# 2015 - 2016 Corvette: Service Bulletin: #16-NA-014: Delayed Engagement After Sitting With Engine Off

## #16-NA-014: Delayed Engagement After Sitting With Engine Off - (Jun 28, 2016)

**Subject:** Delayed Engagement After Sitting With Engine Off

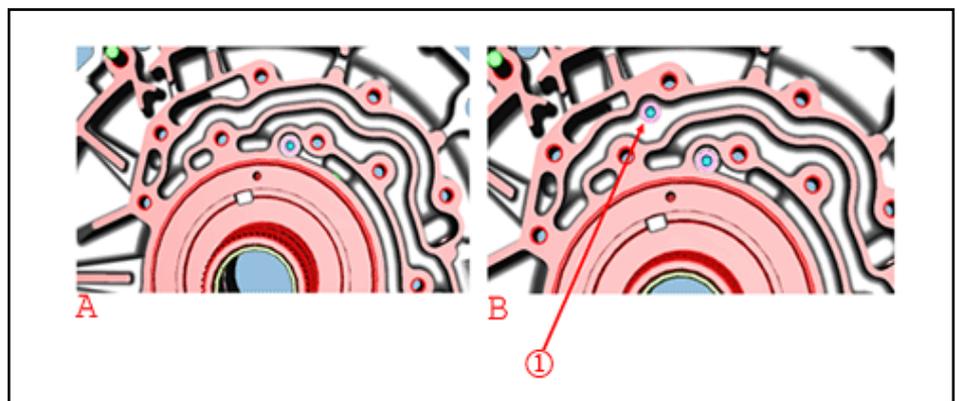
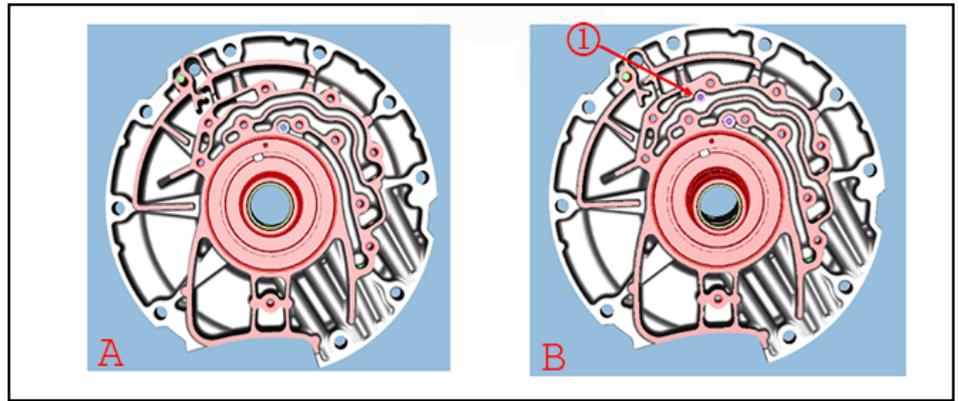
**Note:** The new stator shaft support assembly has a second check ball (1) added (see illustrations).

Install a new stator shaft support assembly that includes an additional check ball. Follow the instructions below to replace the stator shaft

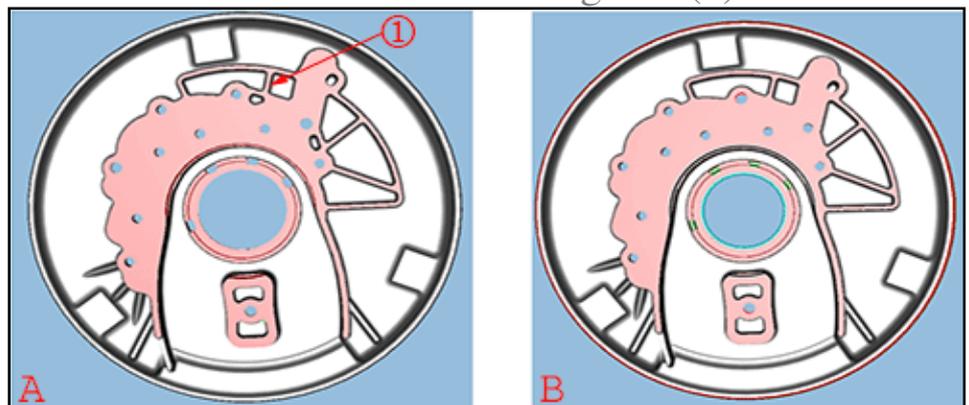
**Note:** The casting void has been eliminated from the underside of the cover for the 8L90 only (see illustration). The 8L45 is not required.
